Modeling Protocol and Agency
Correspondence

- NYSDEC protocol review letter, November 19, 2009
- USEPA protocol review letter, December 15, 2009
- USEPA additional protocol comment letter, January 26, 2010
- Revisions to Cricket Valley Energy Dispersion Modeling Protocol, January 27, 2010

**Cricket Valley Energy
Dispersion Modeling Protocol**

Dover, Dutchess County, New York

**FIGURE 2
SITE PLAN**

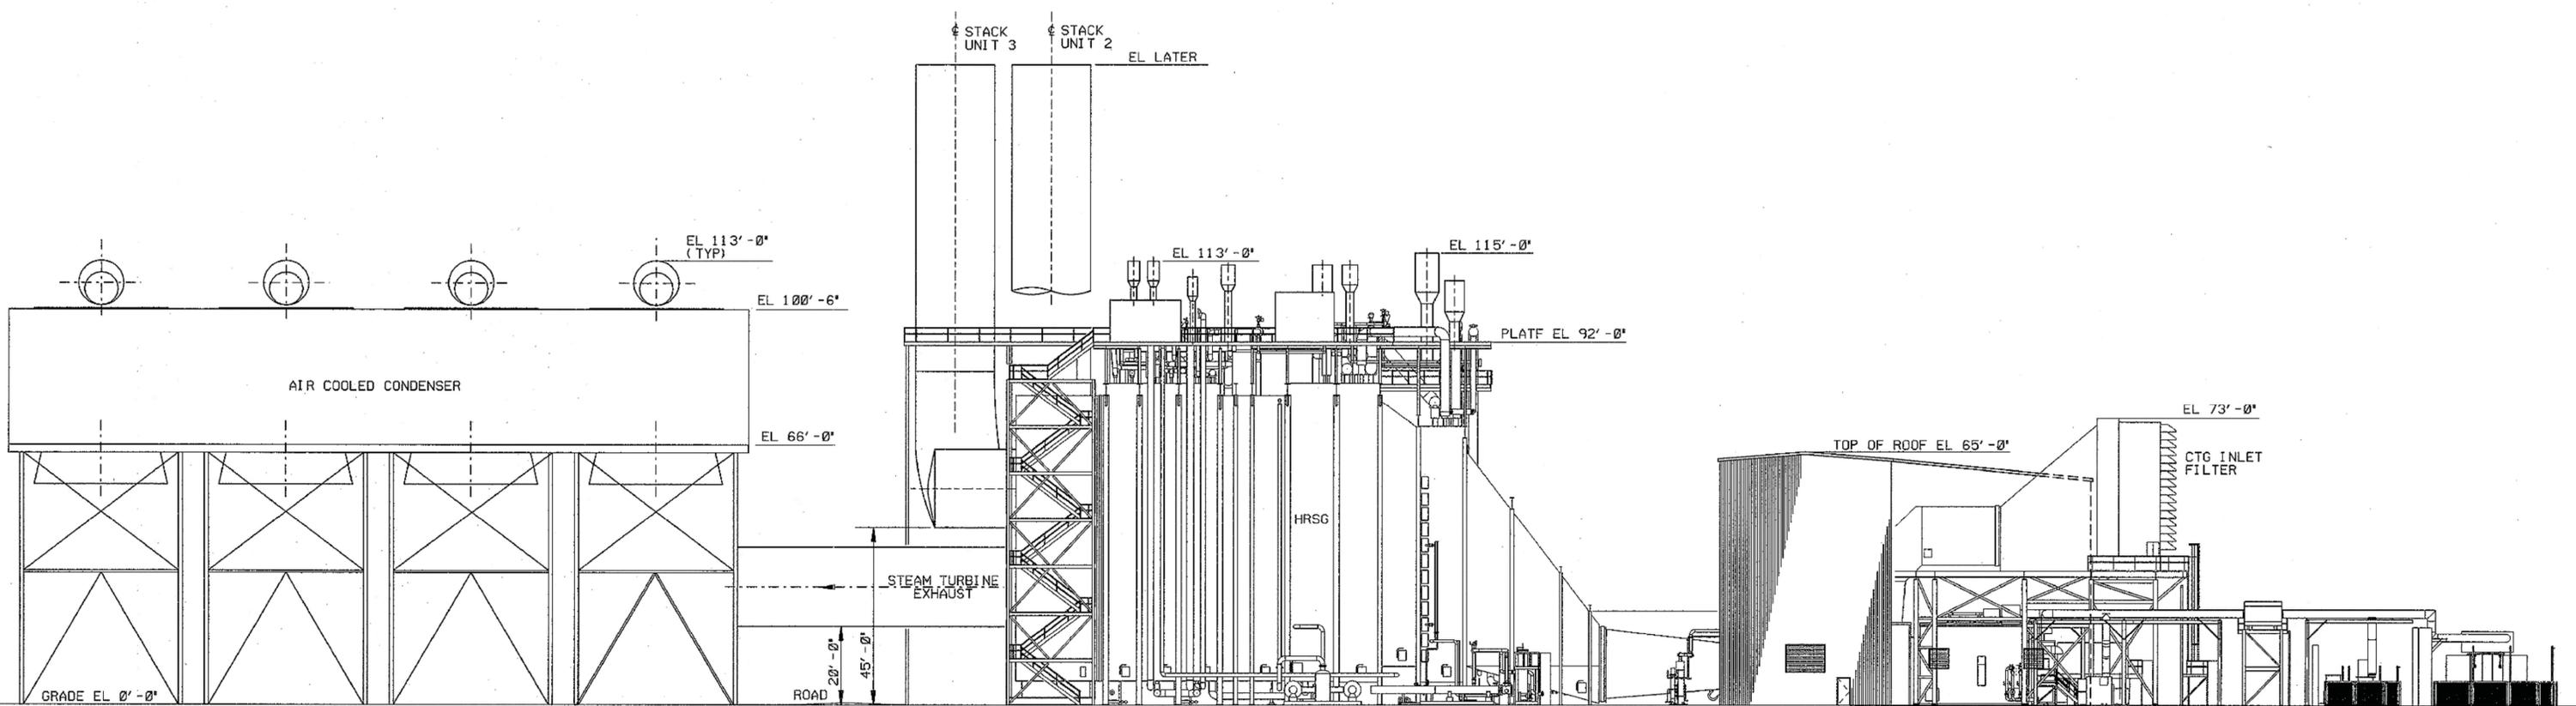
5. A more detailed plot plan which clearly identifies the building footprints, stack locations and fenceline with associated scale should be submitted with the GEP/BPIP analysis. The geo-referenced AutoCAD file for the facility would be preferred.

Comment NY-5. A more detailed plot plan which clearly identifies the building footprints, stack locations and fence line with associated scale should be submitted with the GEP/BPIP analysis. The geo-referenced AutoCAD file for the facility would be preferred.

Response to NY-5. The detailed plot plan and geo-referenced AutoCAD file will be provided with the GEP/BPIP analysis in the Permit Application submittal.
